912 WILLIAMSON DRIVE
(PHILIP ROTHSTEIN
HOUSE)

Nature of Project:
Addition: changes to previously
approved addition façades
(COA 131-16-CA)

Certificate of Appropriateness (COA)

COA #: 131-16-CA & 014-18-CA

WEST ELEVATION PROPOSED

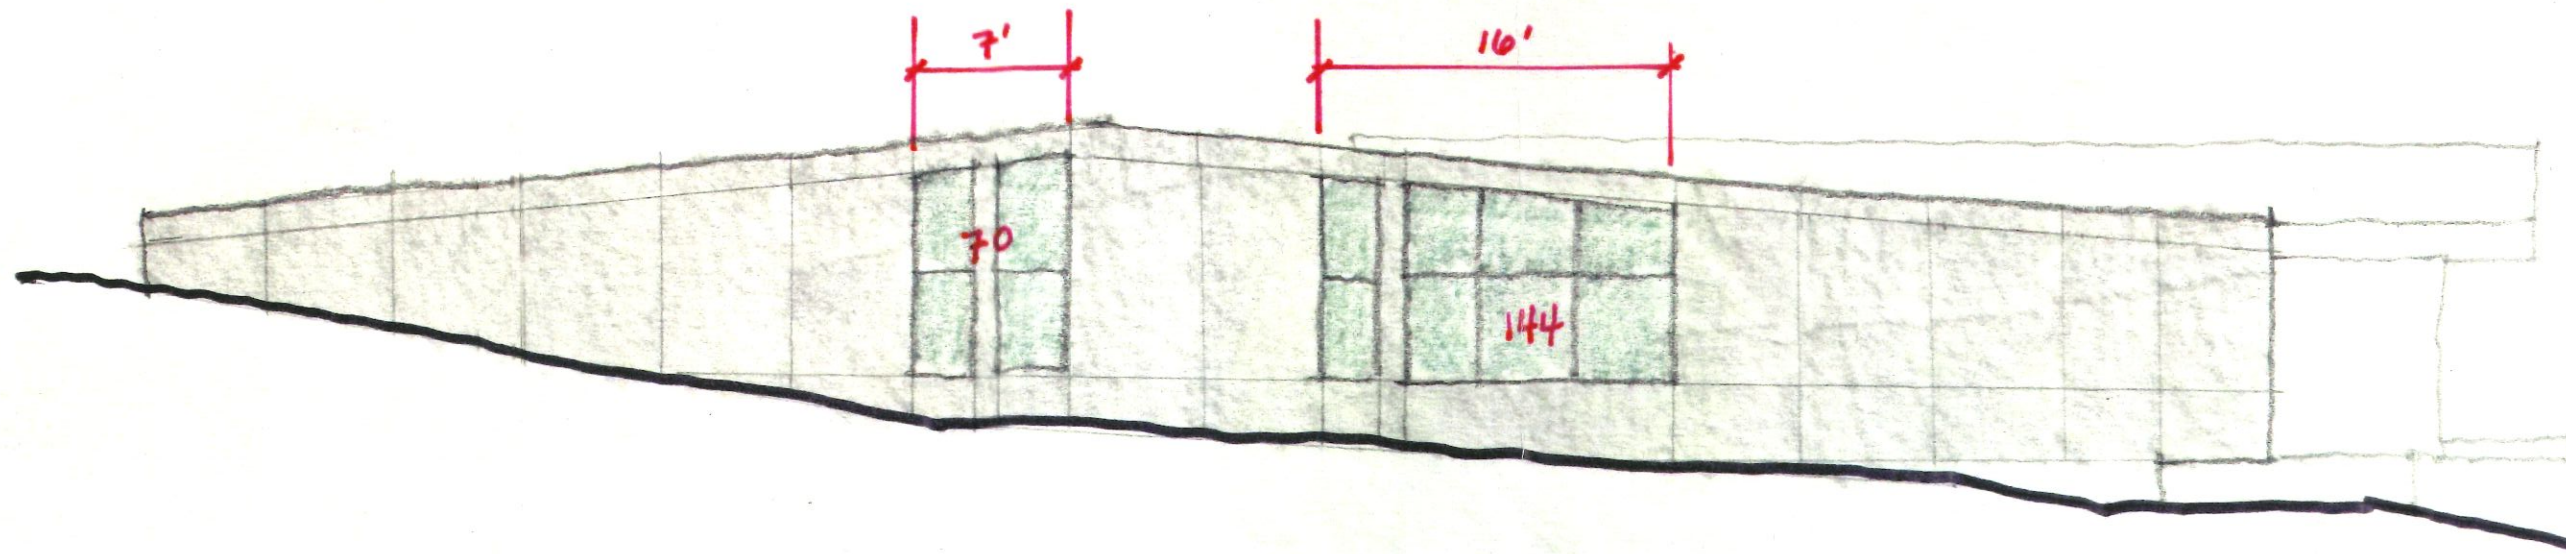
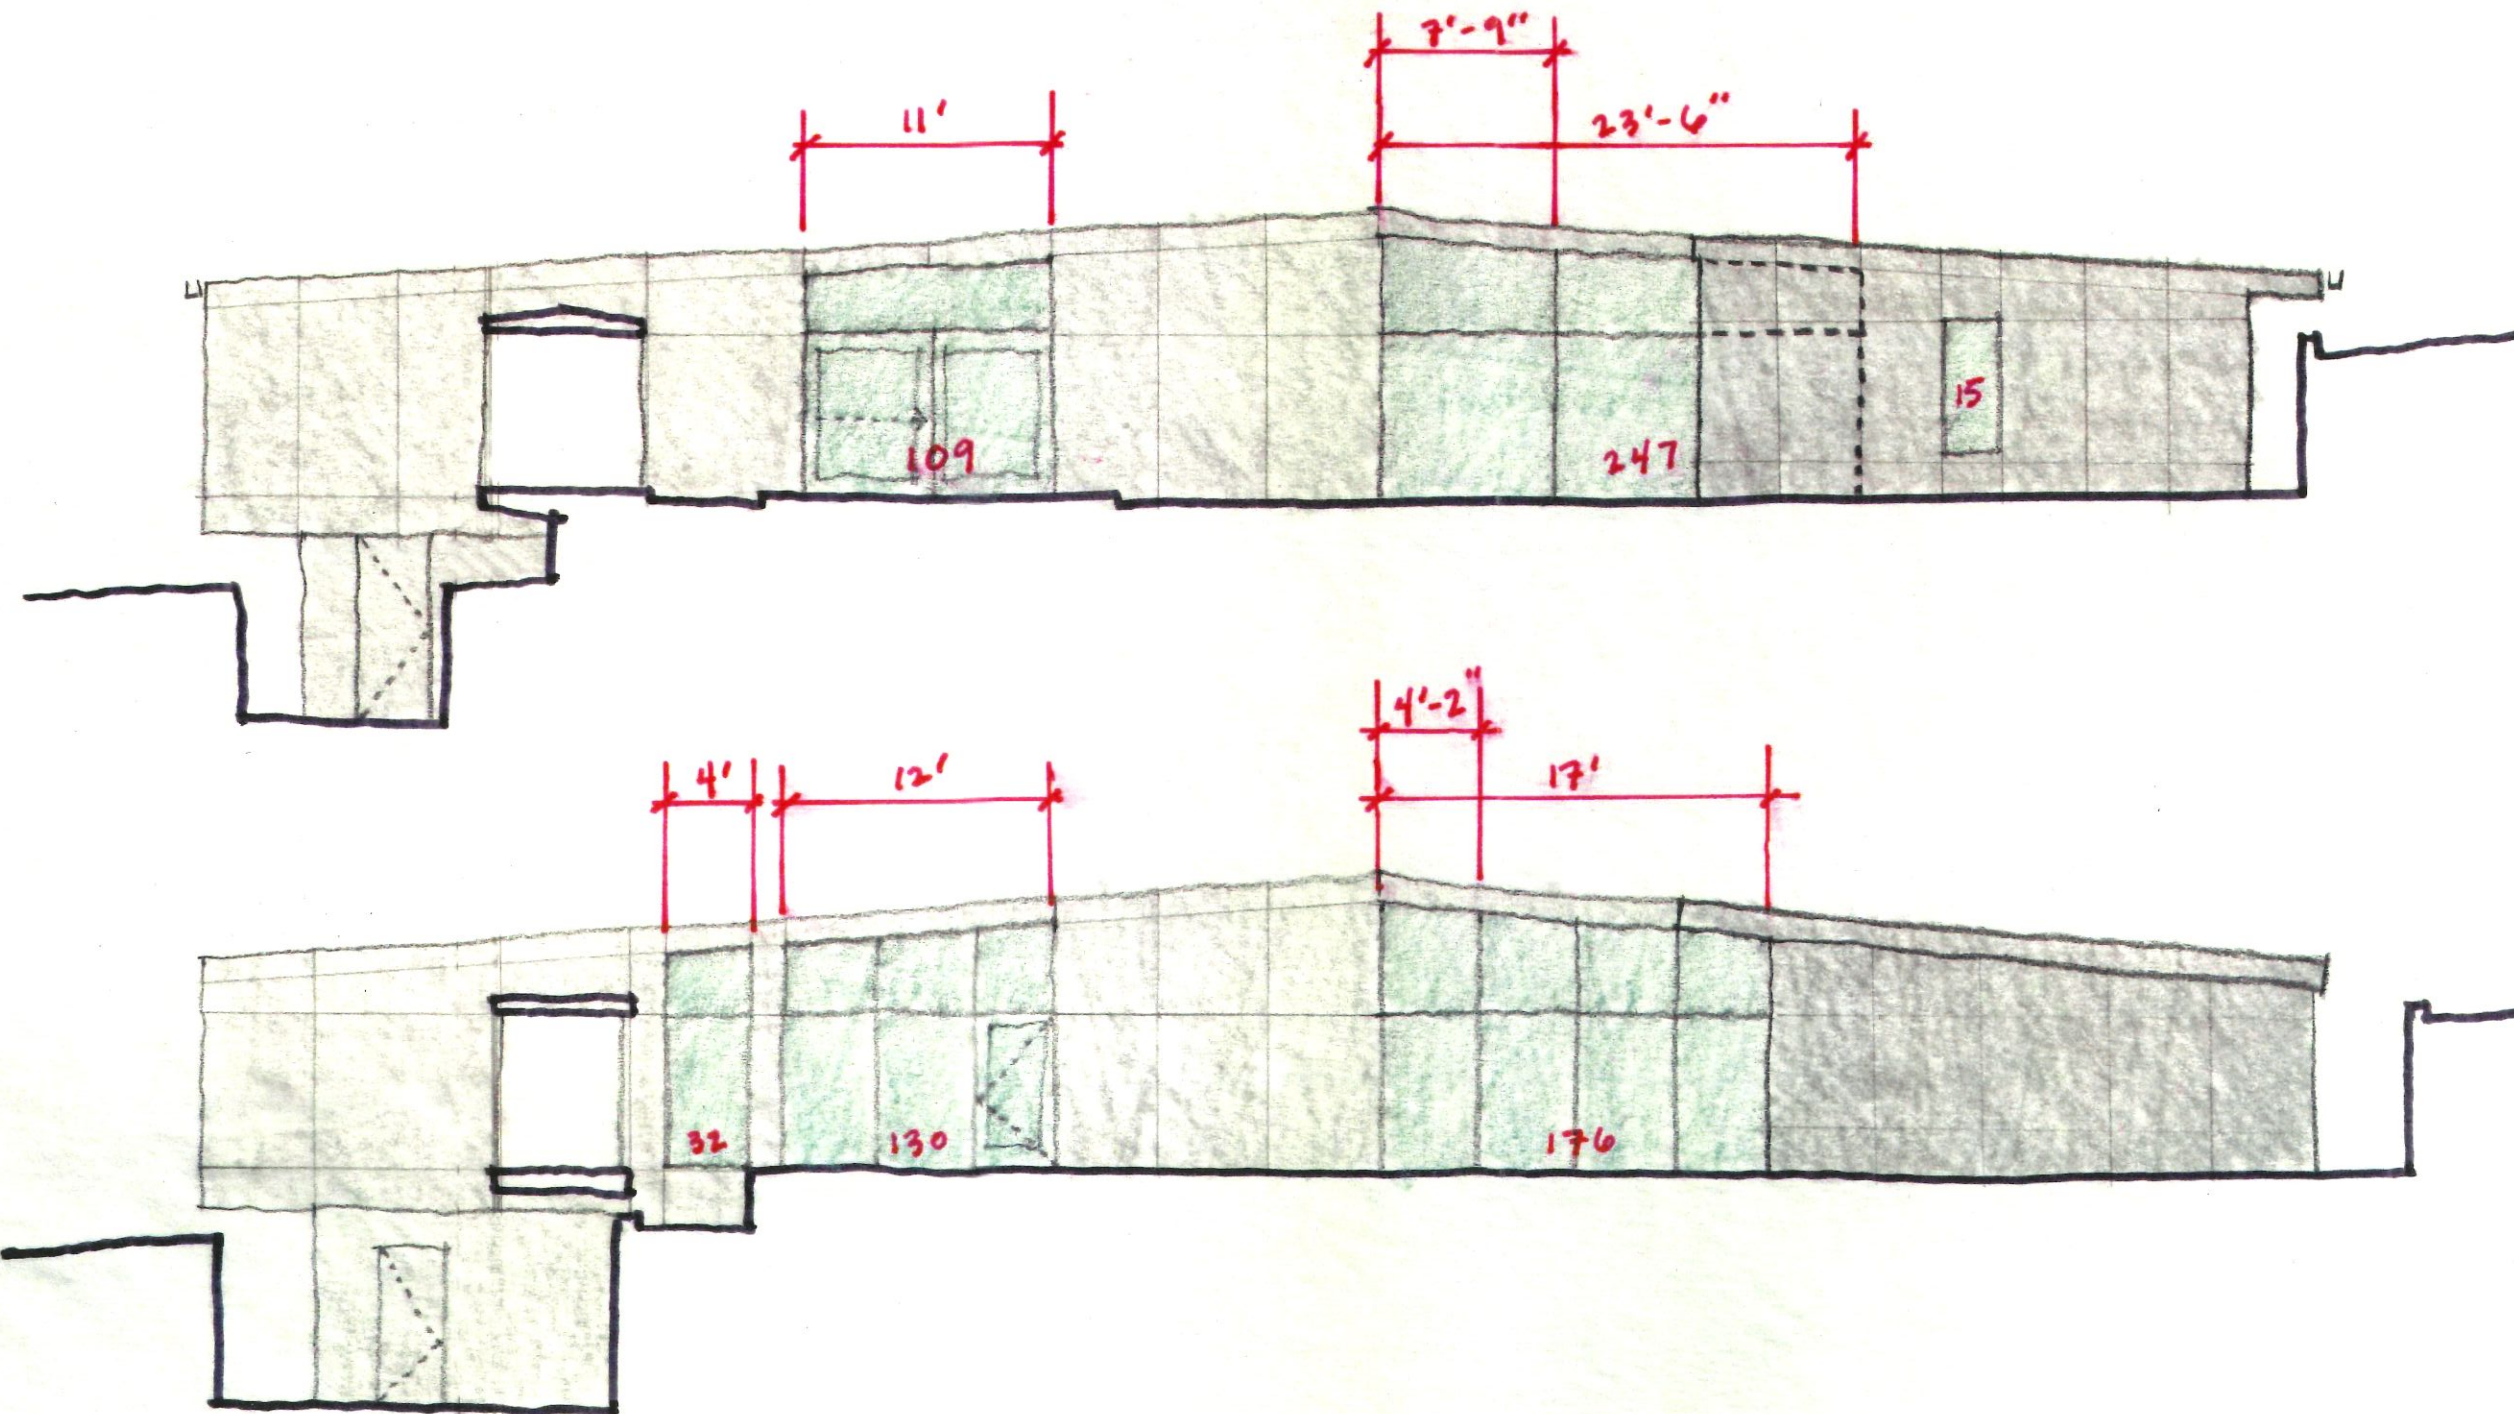
1. Addition of concrete retaining wall so that bedroom windows can be egress. **Reason for change:** Building Code Requirement and unrealistic understanding of grading at the 12 22 16 COA submission.
2. Windows no longer extend to and match roof slope. **Reason for change:** We lowered the ceilings in the bedrooms, meaning windows that previously went to the ceiling would now be looking into attic space.
3. Addition of one operable window in the front office. **Reason for change:** More natural light and ventilation.
4. Addition of gutters with scuppers that drain to the west side of the addition. **Reason for change:** Proper treatment of roof water runoff.

371
EAST ELEVATION PROPOSED

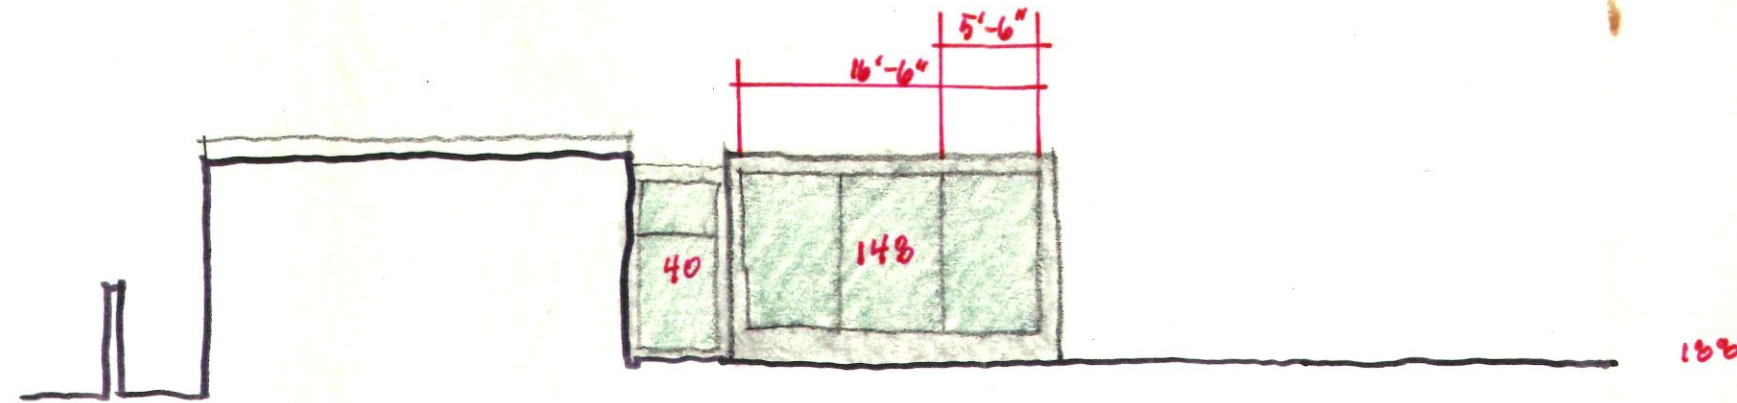
1. A sliding door replaced an inswing door. **Reason for change:** The inswing door was impeding circulation in the hallway.
2. Amount of glazing and window proportion in southern window cluster. **Reason for change:** The sliding door divisions measure 5'-6" in width, which is more similar in width to the existing house (5'-2") than the 4'-0" or 4'-2" width approved on 12 22 16.
3. Addition in the amount of glazing and window proportion and length in northern window cluster. **Reason for change:** The plan configuration changed such that we were able to extend the windows further to the north.
4. Added one casement window in at east facade. **Reason for change:** We needed an egress window in this room.

COURTYARD ELEVATION PROPOSED

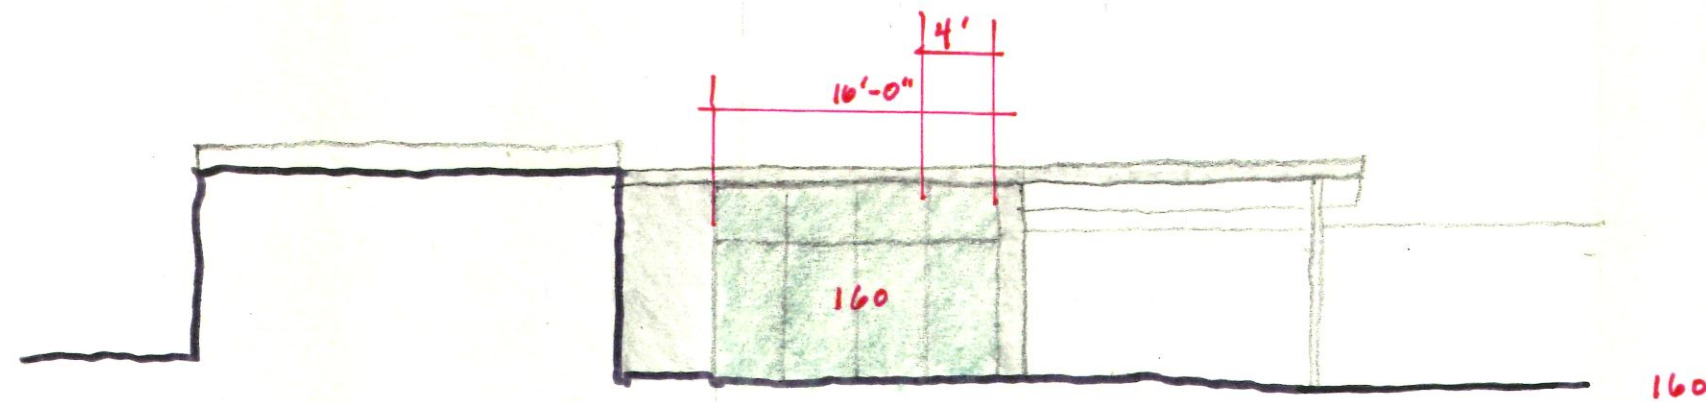
1. More glass and no divisions on south facade in courtyard. **Reason for change:** When the overhang was eliminated over the short leg of the "L", we changed the window configuration such that it eliminated the upper horizontal mullion because we believe that this facade is more in keeping with the south facade directly above the garage, where we are proposing no mullions.
2. Addition of small window between master bedroom and long leg of the "L". **Reason for change:** We believe it is an appropriate place for a window in both plan and elevation.
